**PARK CITY BOARD OF ADJUSTMENT MEETING  
SUMMIT COUNTY, UTAH  
April 16, 2024**

6.A. **1049 Lowell Avenue – Appeal** – The Applicant Appeals the Planning Director's Denial of a Historic District Review Modification for a Roof Modification on an Existing Non-Historic Structure in the Historic Residential-1 Zoning District. PL-24-06061  
(A) Public Hearing; (B) Action

6.B. **317 Ontario Avenue – Variance** – On March 19, 2024, the Board of Adjustment Conducted a Public Hearing and Directed Planning Staff to Draft a Final Action Letter Denying the Requested Variance from the Tandem Parking Configuration at 317 Ontario Avenue. PL-24-06038  
(A) Action

**Subject:** 1049 Lowell Avenue  
**Application:** PL-24-06061  
**Author:** Lillian Zollinger, Planner II  
**Date:** April 16, 2024  
**Type of Item:** Appeal of Historic District Design Review Modification Denial

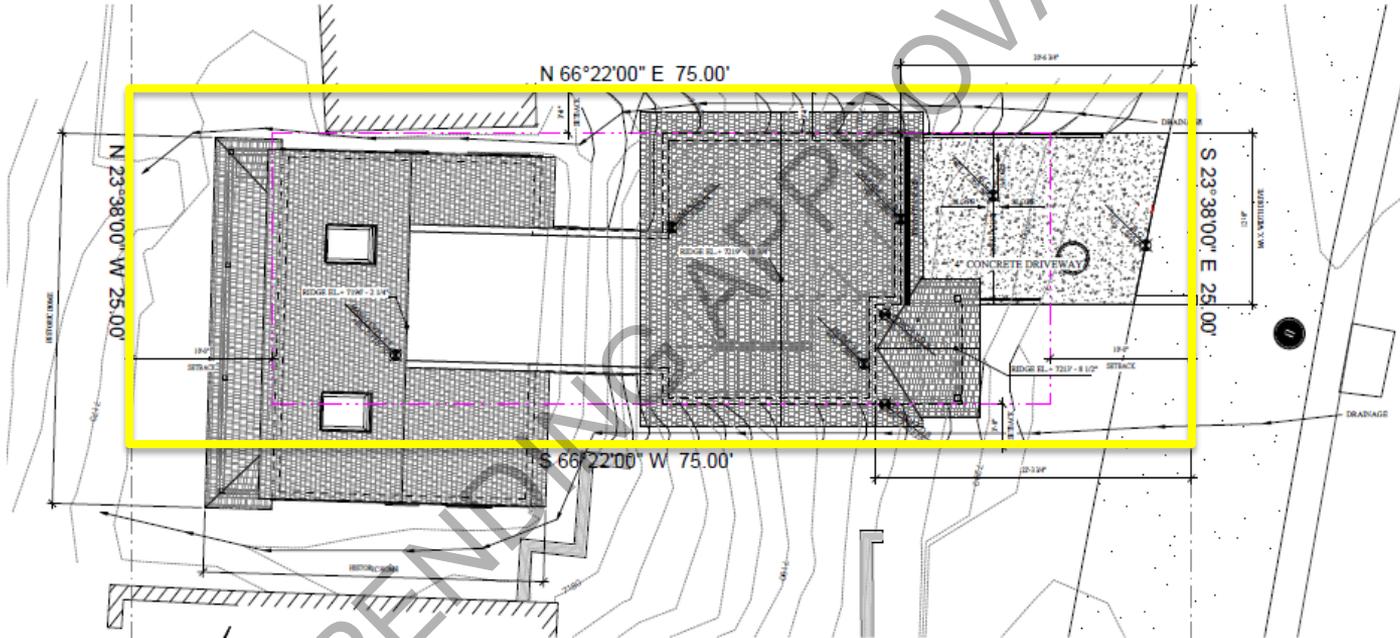
Applicant requests a variance from the required tandem parking configuration; there is inadequate depth between the interior garage wall and end of the driveway to provide two spaces.

Figure 1. Proposed Front (East) Elevation

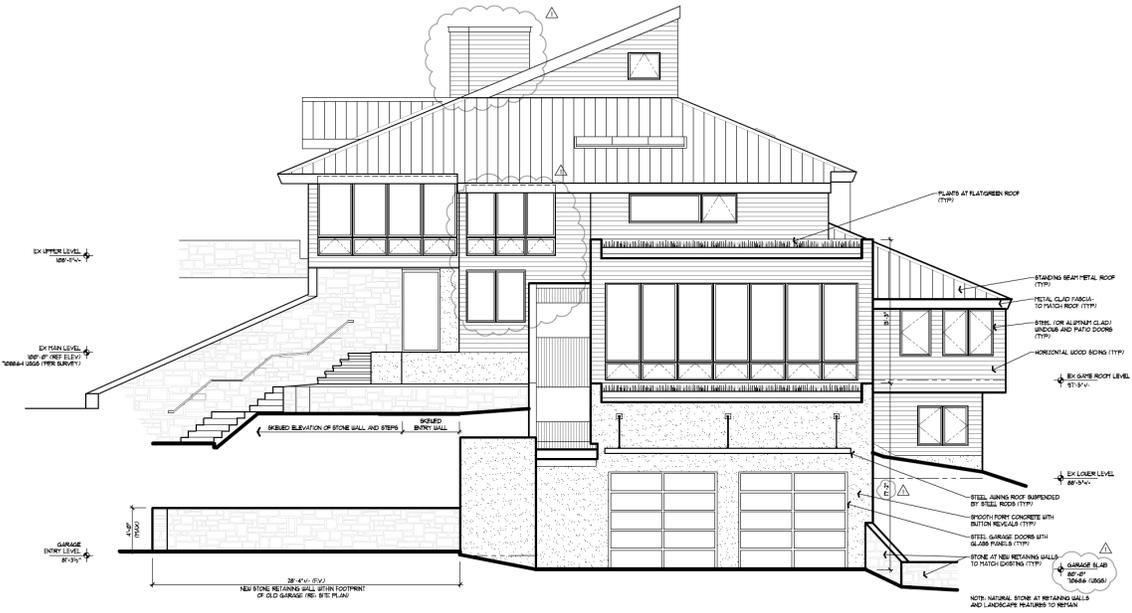
Universal Guideline 4.	<b>Complies;</b> The building massing and scale of the addition is compatible with historic structures as the modules of the addition are similar in scale to building proportions of Historic Structures in the Historic District.
Universal Guideline 5.	<b>Complies;</b> The proposal respects the existing topography as the building mass steps along with grade, and minimizes cut and fill and the use of retaining walls as the building structure itself acts as the majority of site retention.
Universal Guideline 6.	<b>Complies.</b>
Universal Guideline 7.	<b>Complies;</b> The scale and height of the proposed addition follows the predominant pattern of the streetscape.
Universal Guideline 8.	<b>Complies;</b> The size and mass of the proposed remodel and addition is compatible with the size of the site.
Universal Guideline 9.	<b>Complies;</b> No nearby Historic Sites are damaged.
Universal Guideline 10.	<b>Complies.</b>

**ROOF PLAN**  
 1/4" = 1'-0"

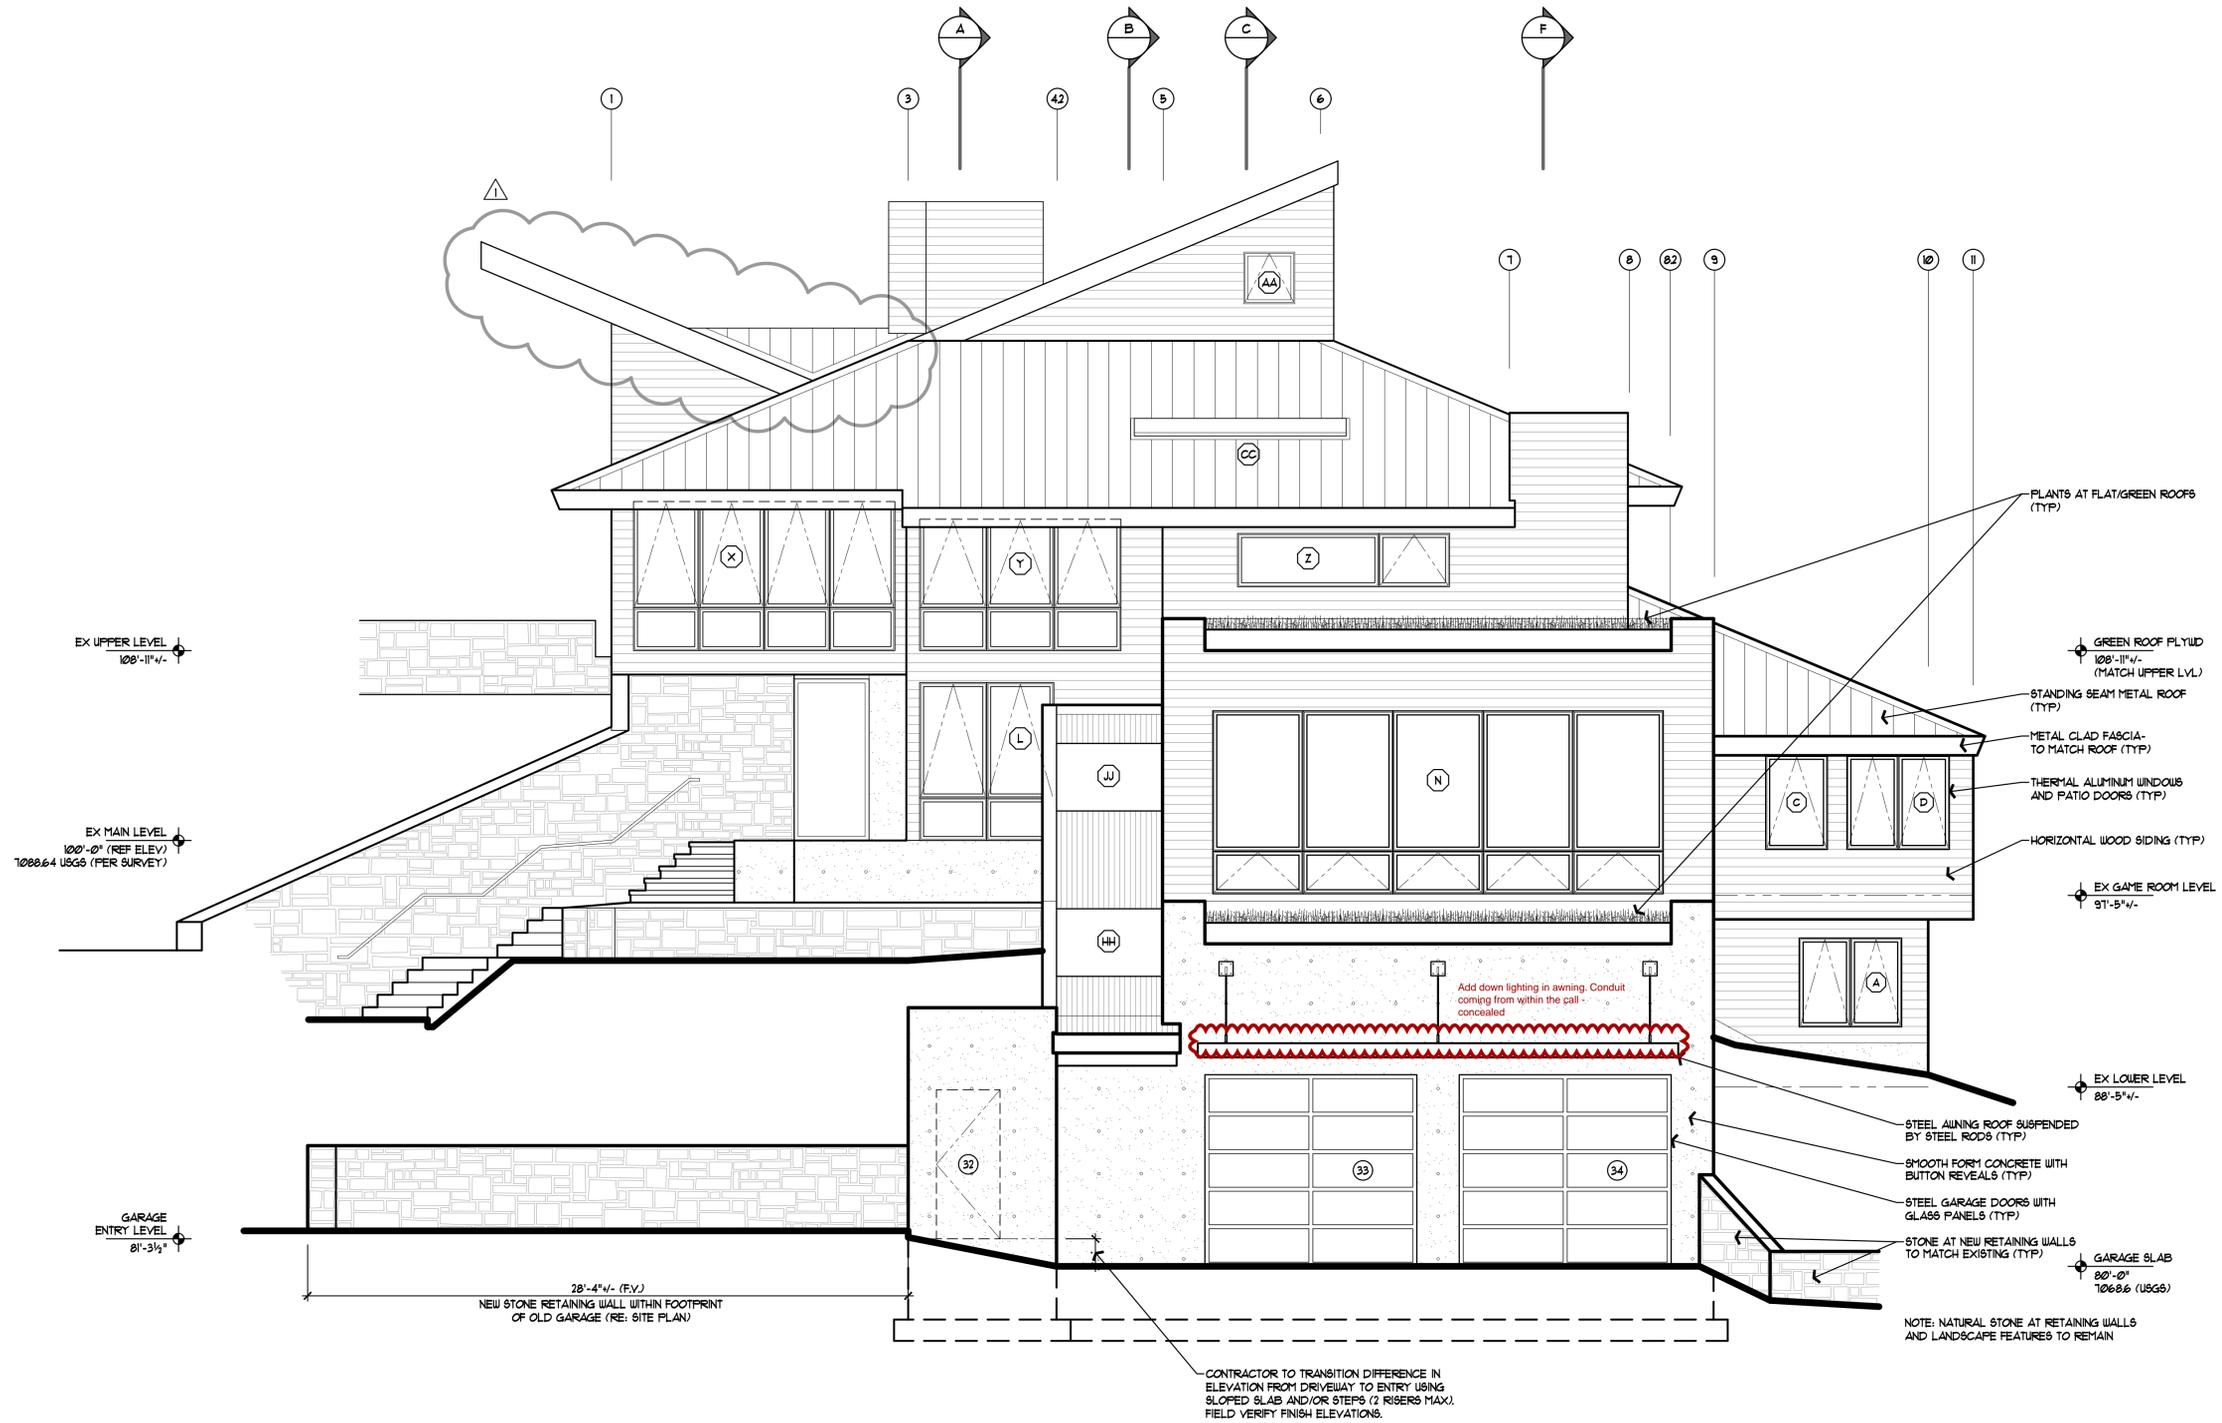
<b>B. Specific Regulations</b>	
2. Primary Structures	Analysis of Proposal
a) Mass, Scale, & Height – LMC <a href="#">§ 15-13-8(B)(2)(a)</a> states: <ul style="list-style-type: none"> <li>• “Buildings that utilize traditional building forms ... are encouraged.</li> <li>• Abrupt change of scale in the character zone is inappropriate...”</li> </ul>	<b>Does not comply:</b> The inverted shed roof modification to the roof form and the design of the roof overhang are not appropriate in the Historic District because it is over-scaled and is not visually compatible with roof shapes in the Historic District.

<p>e) Roofs –          LMC <a href="#">§ 15-13-8(B)(2)(e)</a>, states:</p> <ul style="list-style-type: none"> <li>• “Roofs of new residential infill buildings shall be visually compatible with roof shapes and orientation of surrounding Historic Sites and adjacent buildings that contribute to the character of the Historic District. Sloping of roof forms, such as gable, hip, and shed, should be the dominant roof shapes. Roofs composed of a combination of roof planes, but simple in form, are also encouraged. Roofs shall be in scale with those on historic structures.</li> <li>• Roof pitch shall be consistent with the style of architecture chosen for the structure and with adjacent buildings that contribute to the character of the Historic District, with special consideration given to Historic Sites.</li> <li>• The alignment that is created by similar heights of primary roofs and porches among historic buildings shall be maintained. This similarity of heights in building features contributes to the visual continuity along the Streetscape or character area.</li> <li>• Overhanging eaves, use of bargeboards, soffits, fascia boards, brackets, and boxed eave returns that are consistent with the style of the architecture of the new building and that are compatible with surrounding buildings shall be incorporated.”</li> </ul>	<p><b>Does not comply:</b> The contributing roof form is not changing. The proposed pitch is 4:12. The roof has changed from a gable to an inverted shed roof, a style not seen in, nor compatible with the Historic District. Additionally, the inverted shed roof is cantilevered six feet over the exterior façade, a drastic overhang not compatible with the Historic District.</p>
